# City of Albuquerque

## Environmental Health Department

**Subject:** Review of model for C&C Services – Updated

**Permit #** 3292-M1

Figure 1. Source layout at the southern end of C&C Services' property.

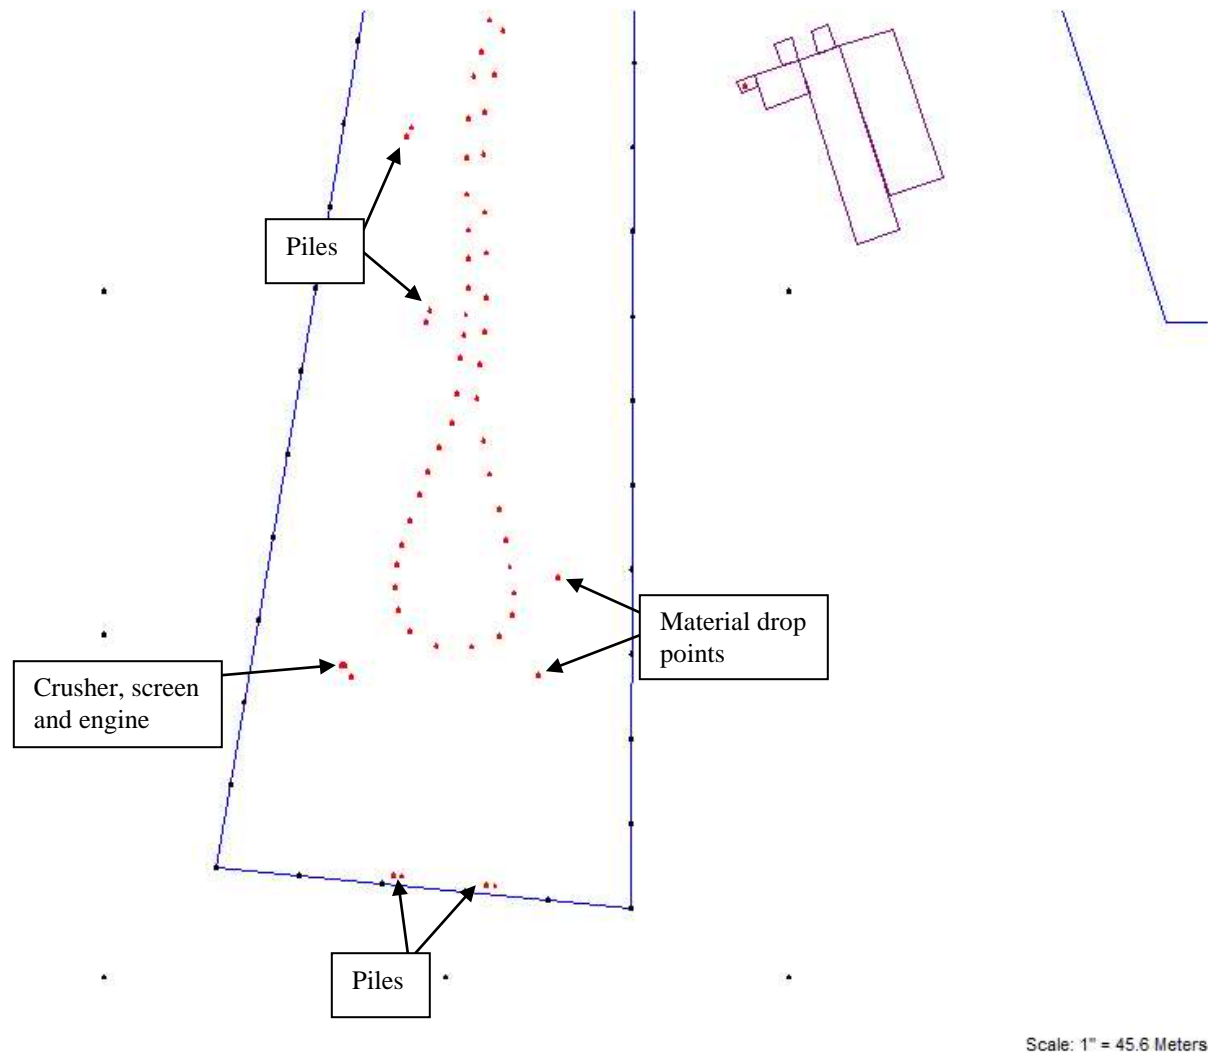
Numerous problems were discovered with the first modeling submission. An internal memo dated 24May2019 discussed those problems in detail and an email was sent to C&C's consultant. One of the problems with the first modeling submission was the location of sources. EHD staff visited the C&C Services site on 22May2019 and requested that the model reflect the actual operations at C&C Services.

Based on modeling, working piles should remain at least 20 feet from the east and west fences. The crusher, screen and engine need to remain at least 60 feet away from the fence to the east and west, and 175 feet away from the fence to the south. The model has no sources north of the entrance so all equipment and piles must be kept south of the entrance. C&C is restricted to a maximum of 53 haul trucks per day because the pound per hour emission rate for the haul road is based on this number of trucks.

Figure 2. 1-hour NO<sub>2</sub> model results.

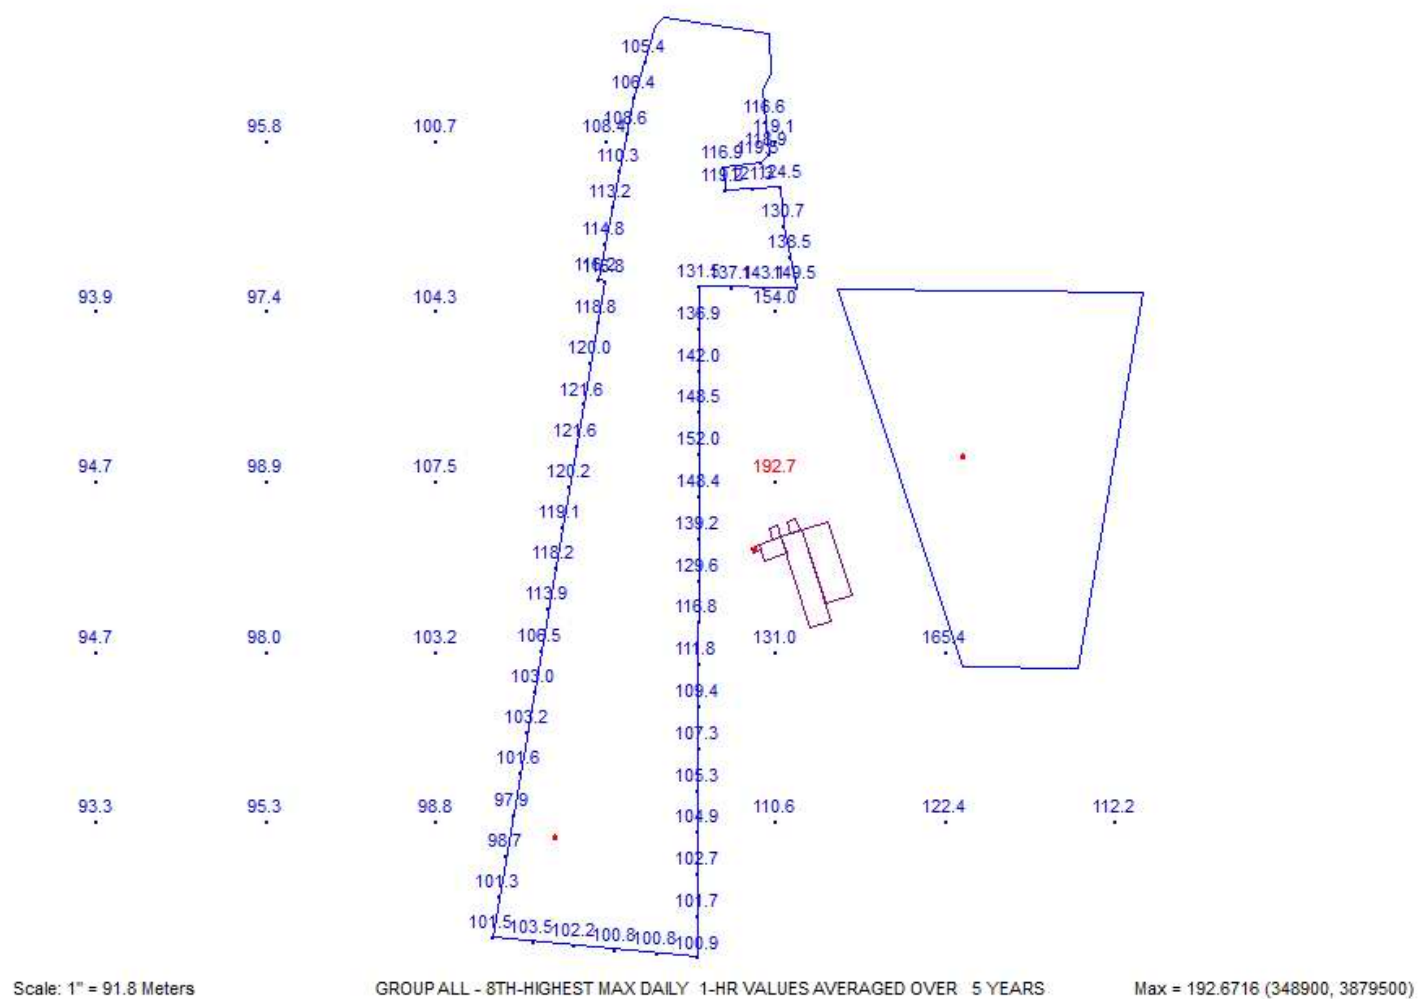
The 1-hour NO<sub>2</sub> CIA model run by EHD shows significantly different results than the model submitted by C&C's consultant. Submitted 8<sup>th</sup> HMD<sup>5</sup>years = 178.8  $\mu\text{g}/\text{m}^3$  while EHD 8<sup>th</sup> HMD<sup>5</sup>years = 192.7  $\mu\text{g}/\text{m}^3$  in the same location. There is no significant contribution from C&C Services to this exceedance but the difference was investigated to determine why it occurred. After several test runs it was determined that the use of new MET data and ozone data by EHD caused the different result. There is also a minor difference caused by the updated NO<sub>2</sub> background value used by EHD. During testing it was noted that the EHD refined receptor field is slightly different than the refined receptor field used by C&C's consultant. If one runs the modeling exactly as submitted with updated MET and ozone data, additional exceedances may be found but once again the C&C contribution is not significant.

After examining the exceedance in the 1-hour NO<sub>2</sub> model and determining that C&C's contribution was not significant, EHD chose the next highest value from the 8<sup>th</sup> HMD<sup>5</sup>years using the EHD refined receptor field. EHD used different meteorological data (2014-2018 vs. 2001-2005) and updated ozone data compared to C&C's consultant.

Figure 4. 24-hour PM<sub>10</sub> model results without background and without C&C sources included. The highest modeled impact does not change and other modeled impacts inside and near Albuquerque Asphalt only decrease slightly.

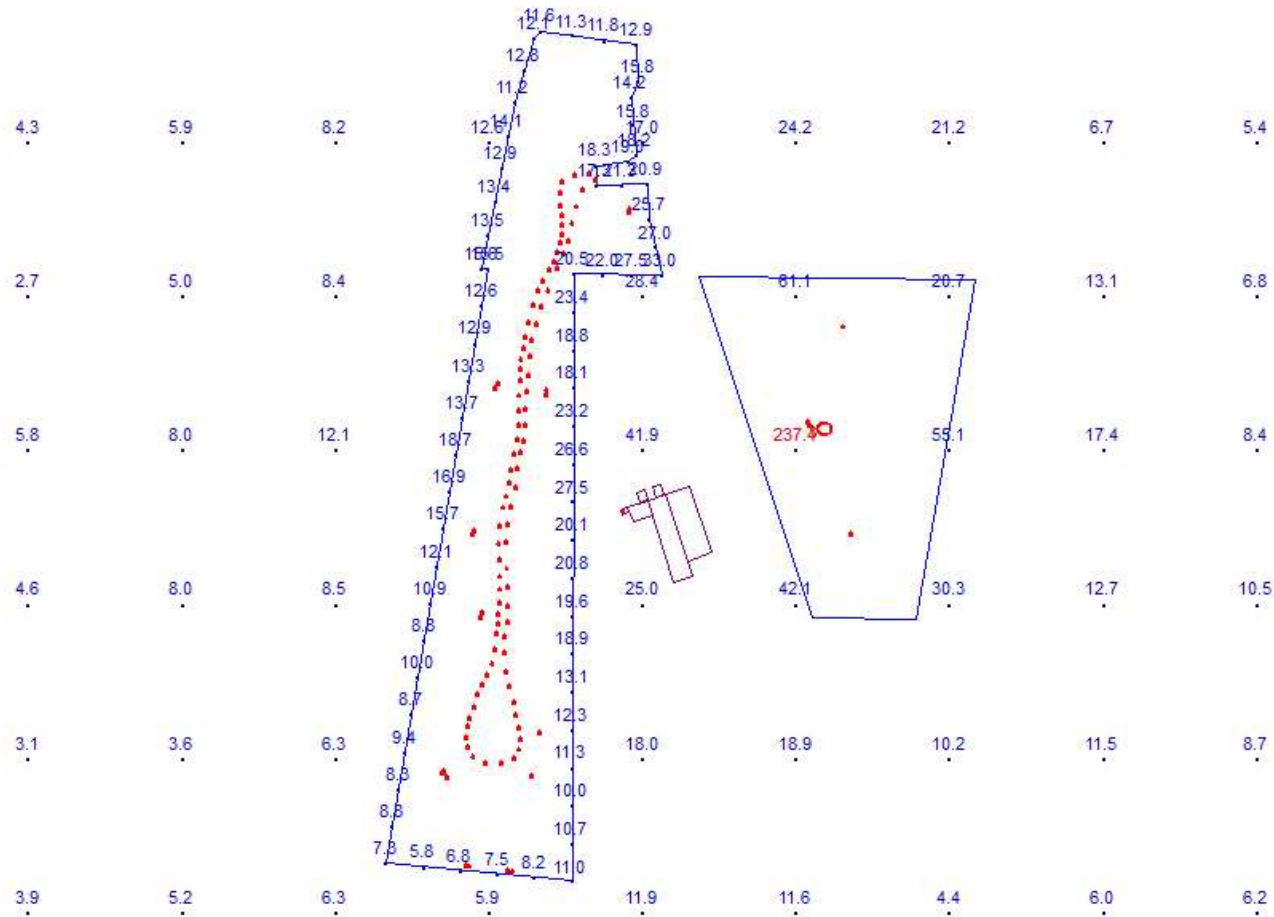
The same issue mentioned in the first paragraph of the discussion regarding C&C sources not having hourly factors also had to be corrected in this revised model. The emission rate of one of the units also had to be corrected to match the updated emission calculations. These corrections made by EHD resulted in different modeled impacts from the modeled impacts reported by C&C's consultant. The modeled exceedance and the other high modeled value inside Albuquerque Asphalt (Figure 3) were investigated to determine if C&C Services was causing either of these modeled results. It was determined that C&C was not causing either high modeled value. The modeled exceedance does not change with or without C&C sources in the model and the other high value only changes a minor amount (Figure 4). Because these receptors are inside Albuquerque Asphalt property, the contribution of Albuquerque Asphalt sources at these receptors cannot be considered. This is because these receptors are not located in ambient air relative to the Albuquerque Asphalt sources. Therefore, EHD selected the highest second high value outside Albuquerque Asphalt's fence line as the result to be compared to the standard (Figure 3). This result shows no exceedance of ambient air quality standards.
